Government of the District of Columbia
Department of Transportation

MEMORANDUM

DATE: March 25, 2019

SUBJECT: ZC Case No. 06-10D – Art Place Block B

Attachment 2A
WB50 Inbound Berth 1

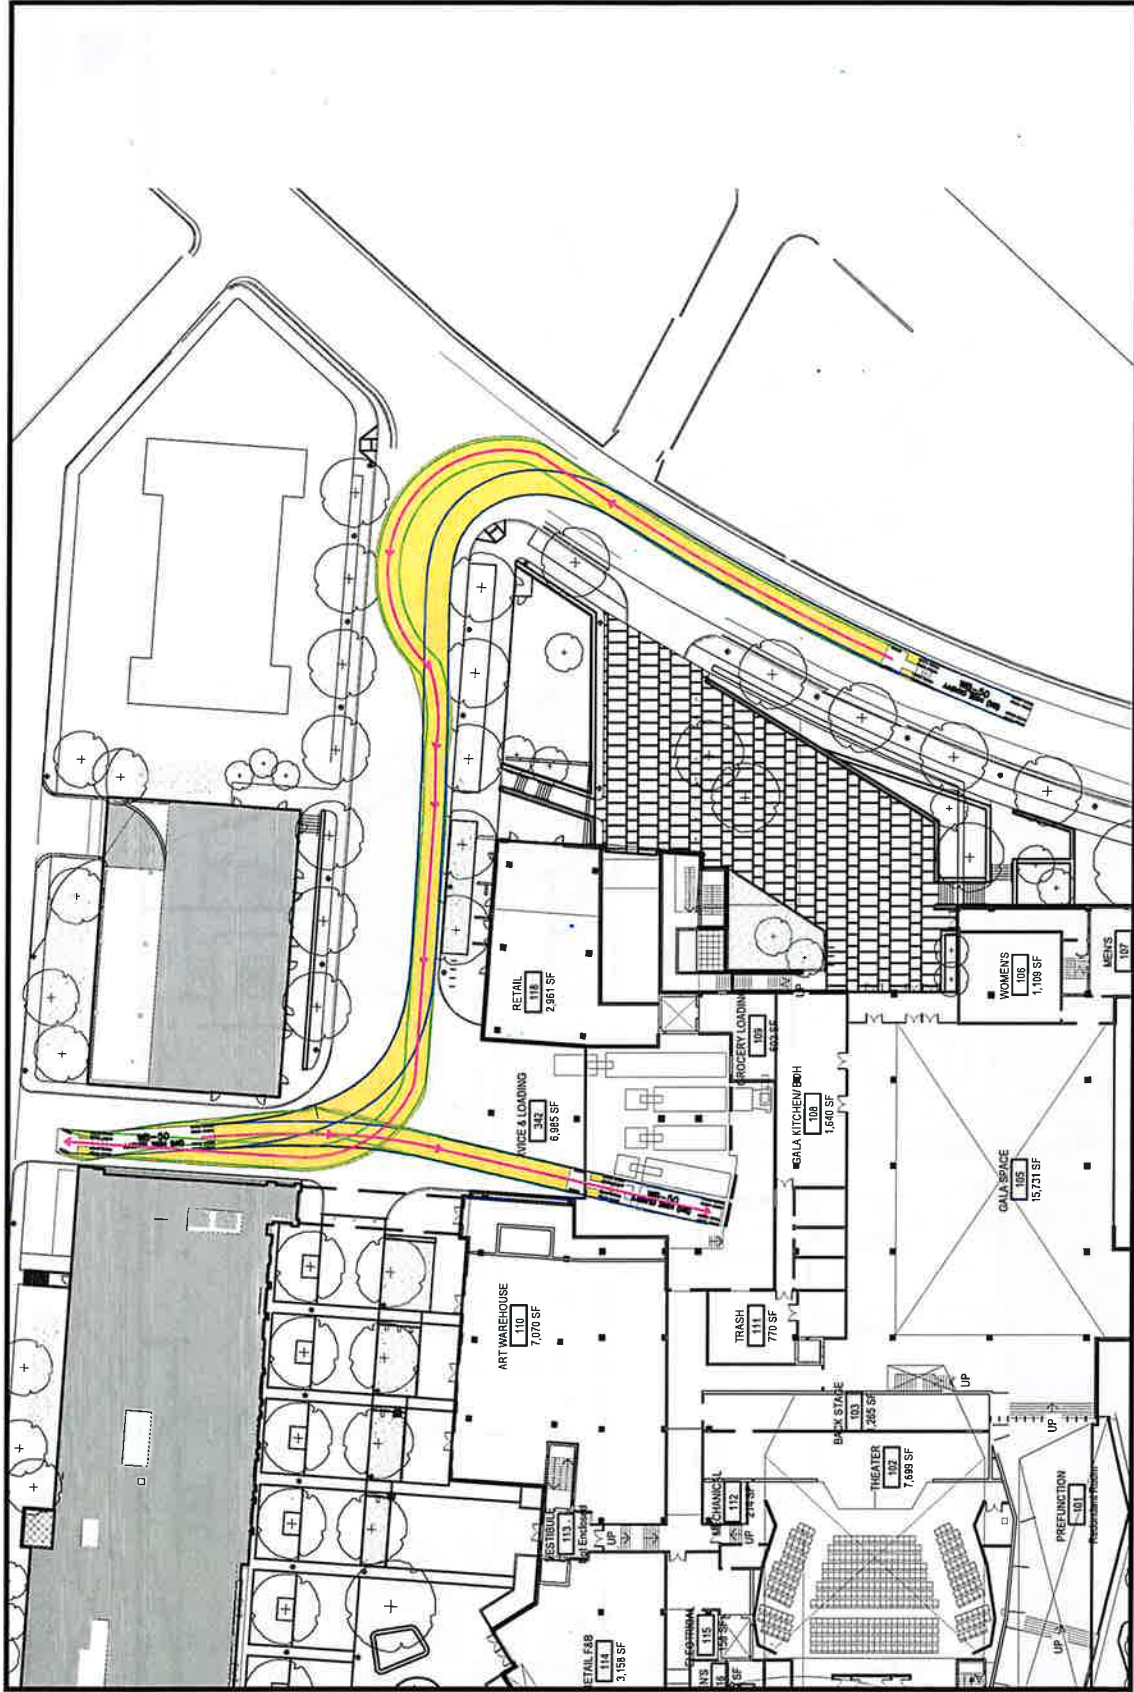
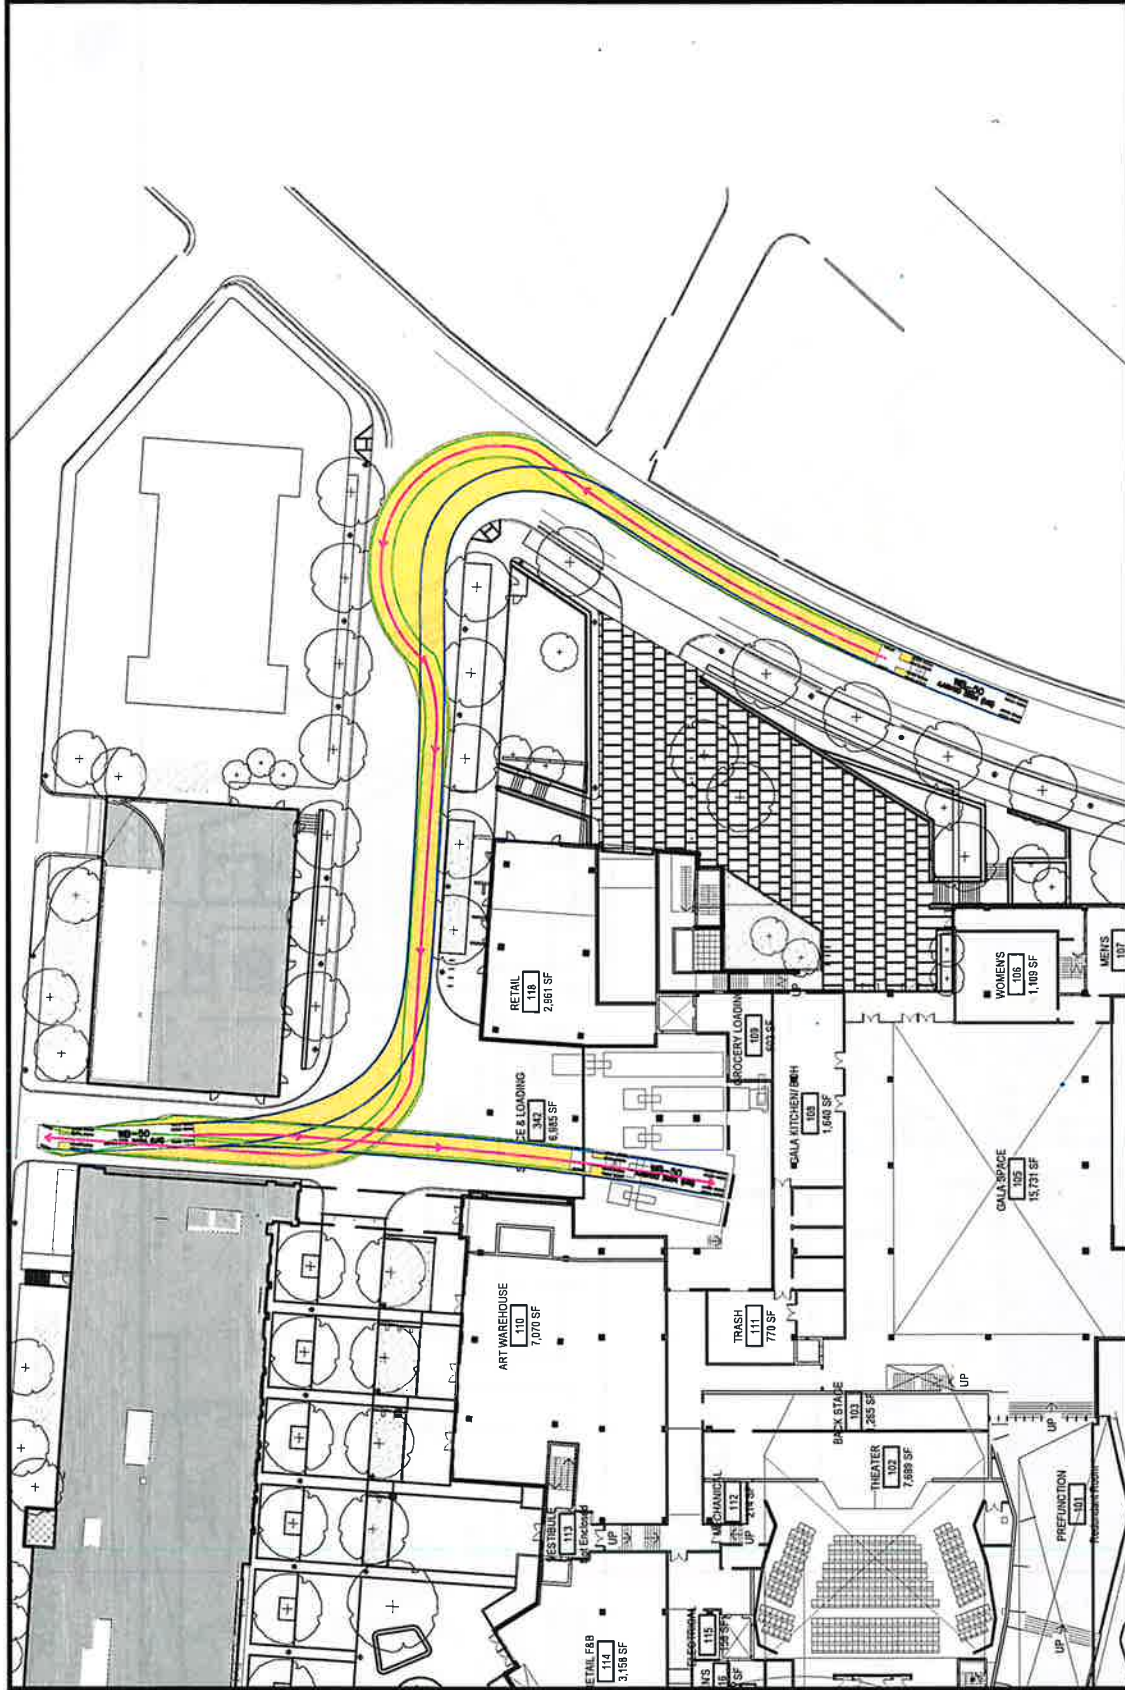
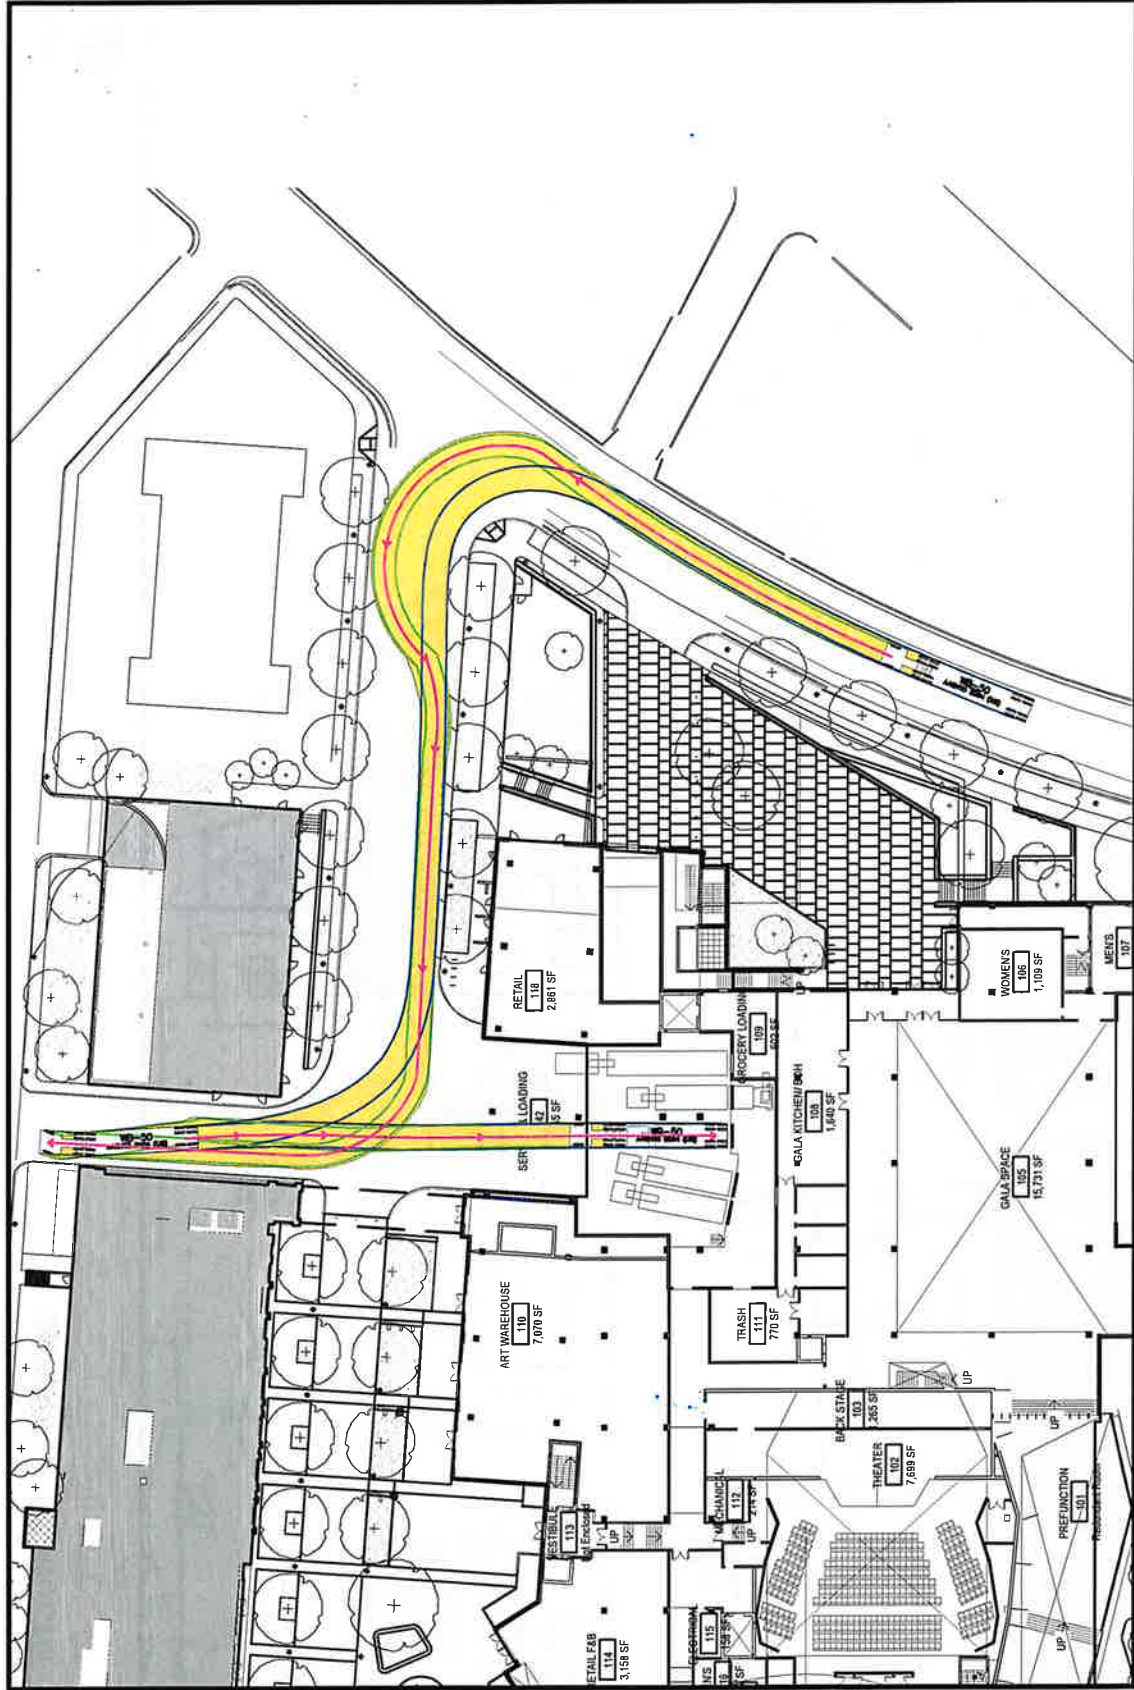
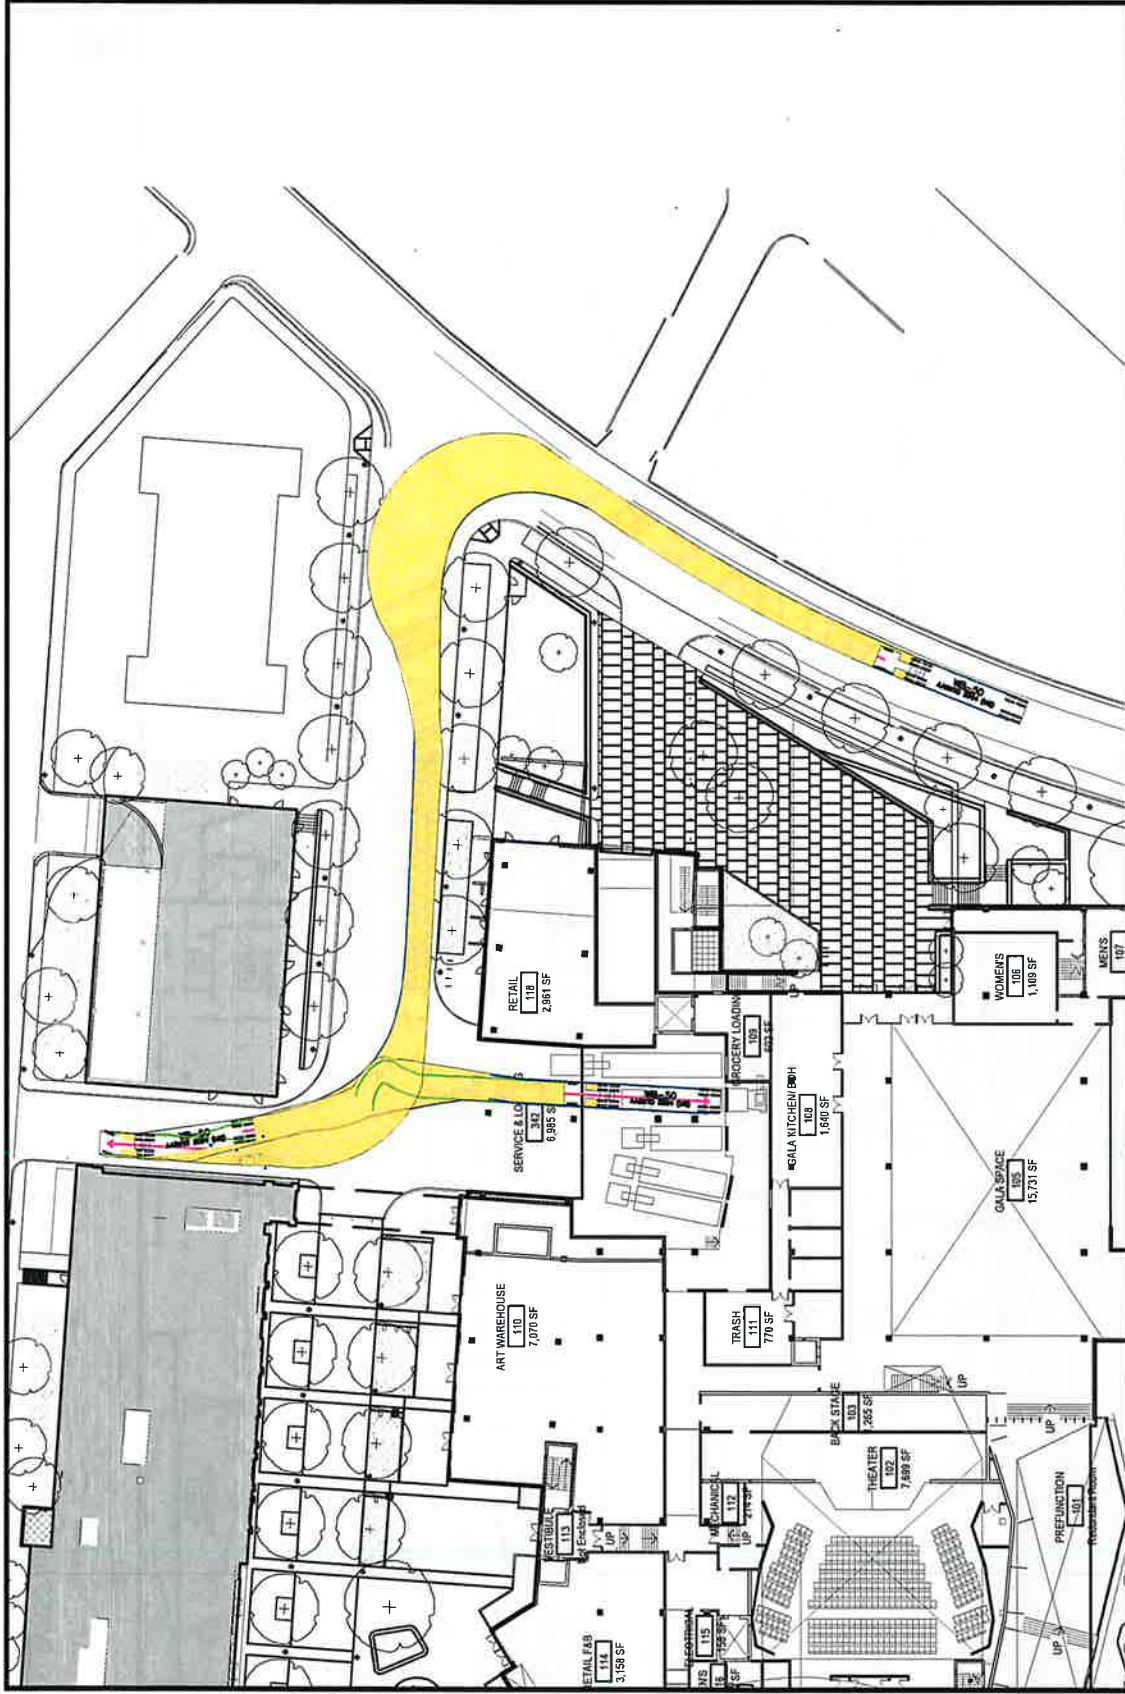
Comment #6: *In Appendix I, there are several instances of trucks clipping corners and going over curbs, even on the private street. Also, since Kennedy Street will be realigned in the future, the analysis should be done with that future alignment. On page I-12, you'd need to restrict parking on Kennedy to make the turn, so you'll need to discuss in your analysis how and when that parking would be restricted.*

Response: Updated swept area diagrams are provided in Attachment 2. The truck size for the site has been reduced to SU-50 for the commercial uses in the eastern building and SU-30 for the residential uses in the western building. A revised Loading Management Plan is included as Attachment 3. Loading for the western building via the public alley would no longer encroach on the parking area on Kennedy Street prior to entering the alley.

The Kennedy Street alignment has not yet been fully designed; therefore, it would be difficult to provide detailed truck turning diagrams on the future alignment. At the time that the realigned roadway is designed, trucks will be accommodated with appropriate curb radii and roadway widths.
